**Planning Commission Application  
PART I**

Address of Subject Property 3732 MONTROSE ROAD

November 2, 2016

Additions and Renovations to St. Luke's Church (Planning Commission P-16-24)  
#166009-00

Sheet Number  
**C3.0**

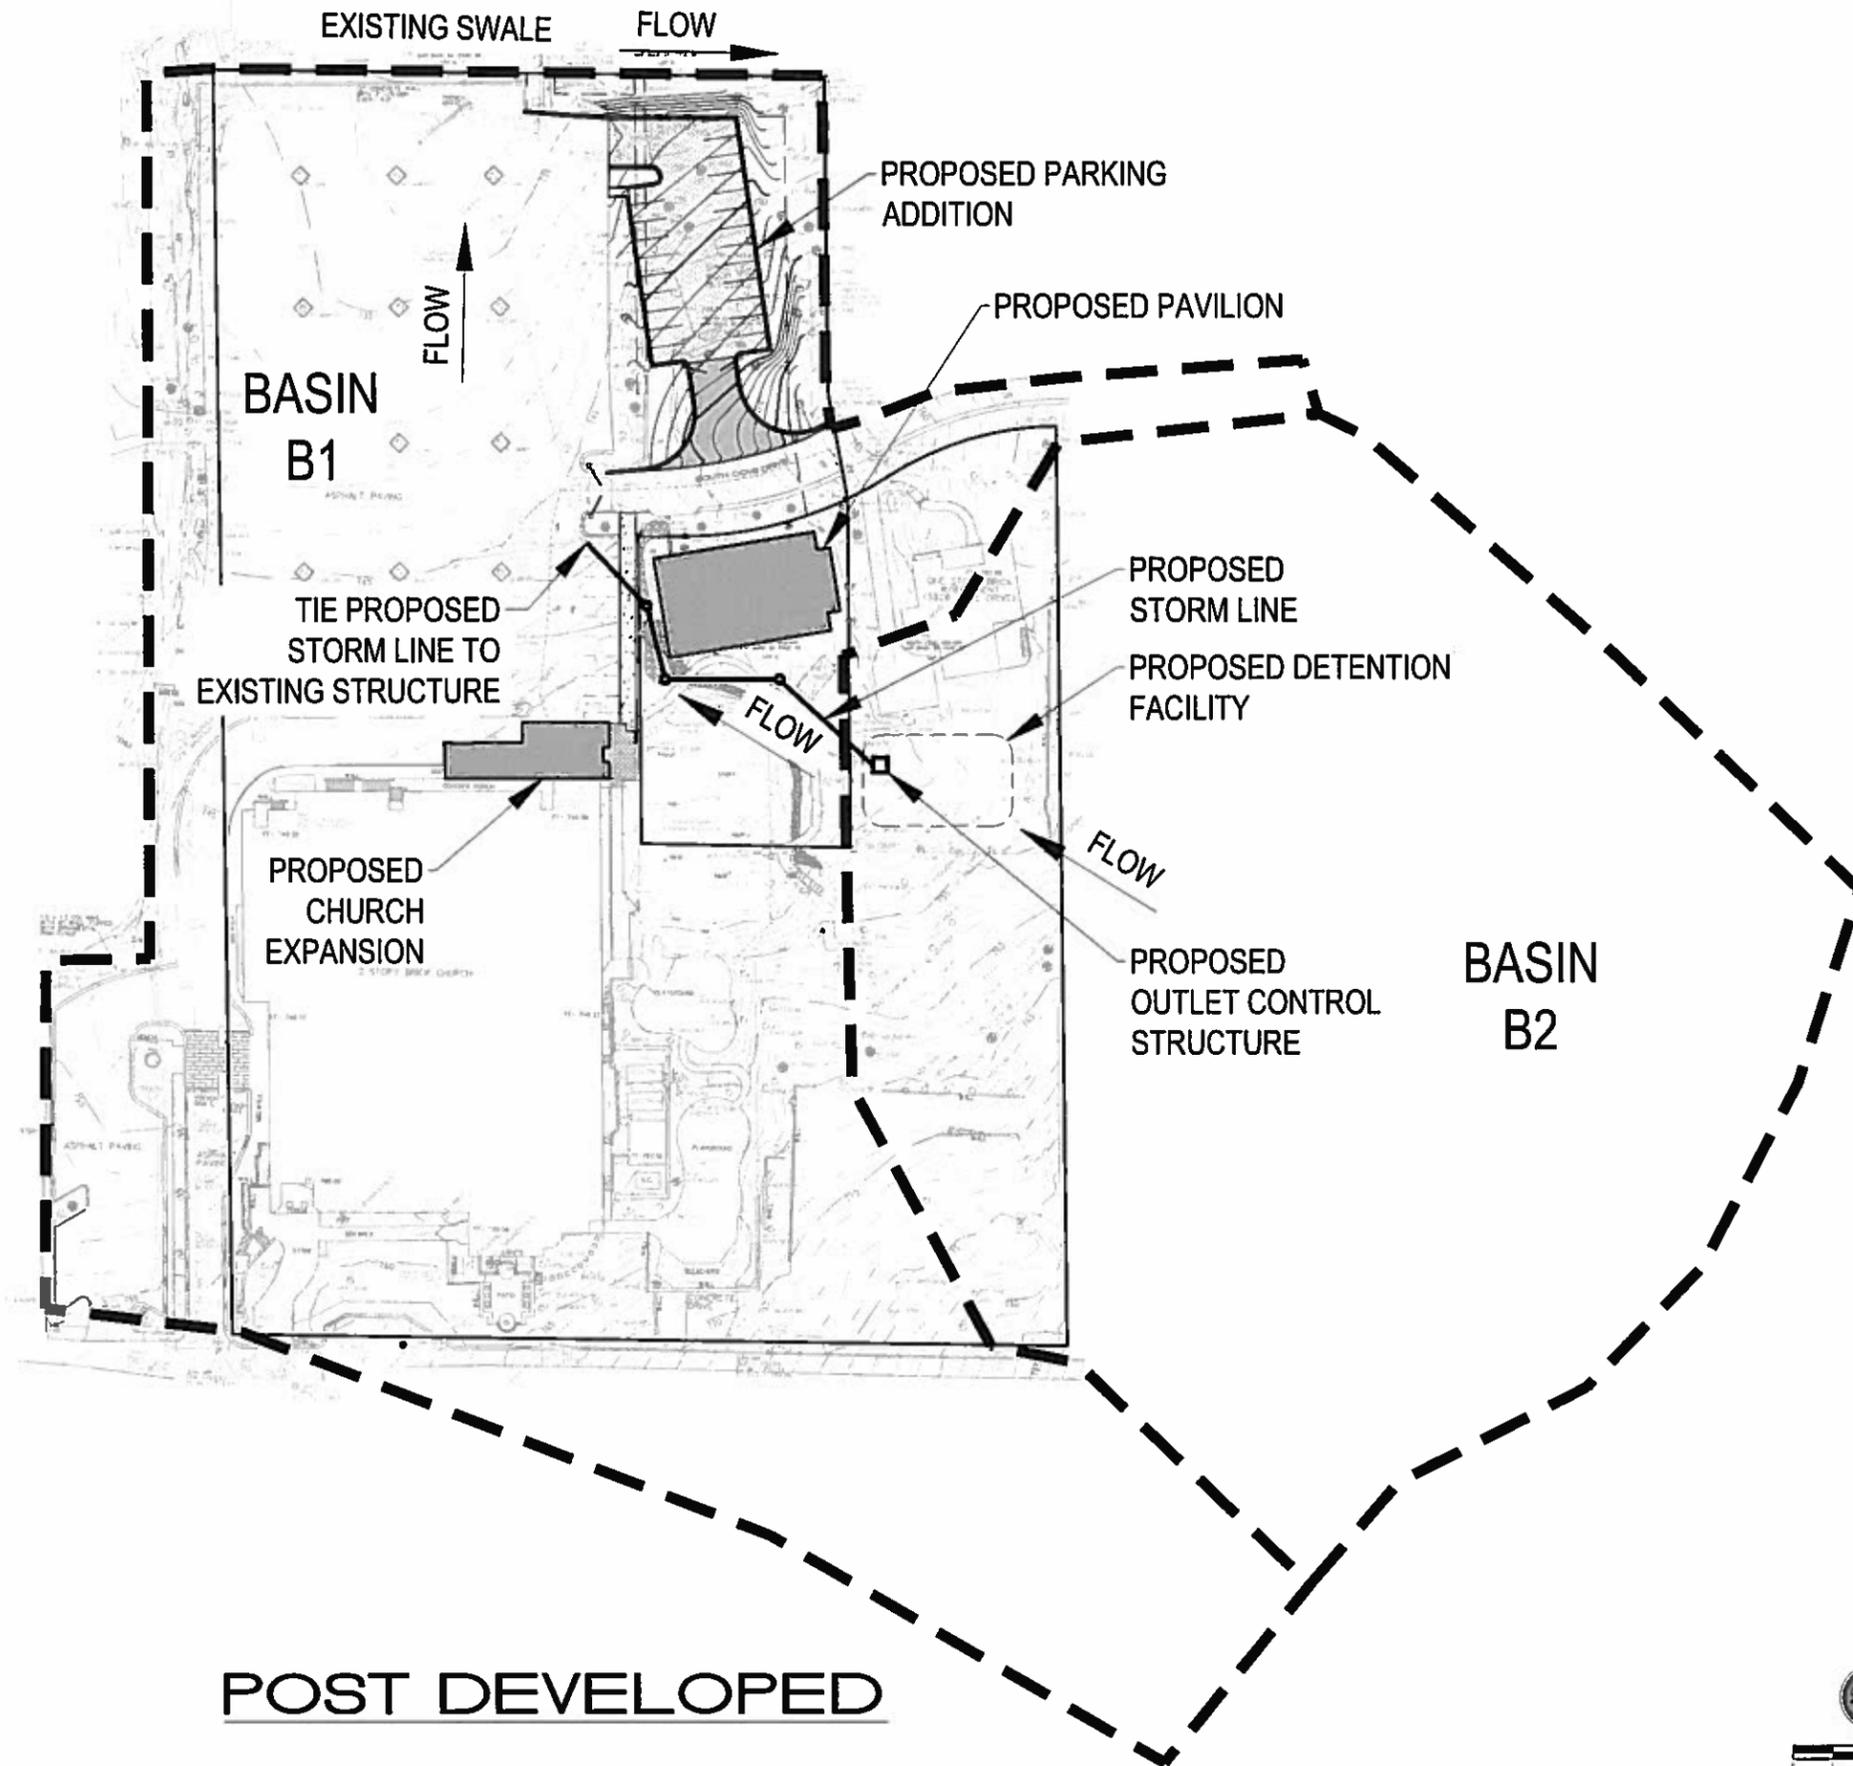
- *Analysis of drainage implications from the new parking lot.*

Response – See Attachment E consisting of a drawing and a narrative prepared by LBYD Consulting Engineers regarding the overall control of storm water on the site. The first drawing is of the new parking lot showing its location, size, preliminary grading and indicating how runoff will be handled. Essentially, storm water from this lot will be directed back on to the existing St. Luke’s parking lot and none across the property line to the north. Overall, the site will have a new detention facility located between South Cove and Montrose to insure that post development runoff is less than that predevelopment. The detention pond will have an outlet control structure to retain storm flows.
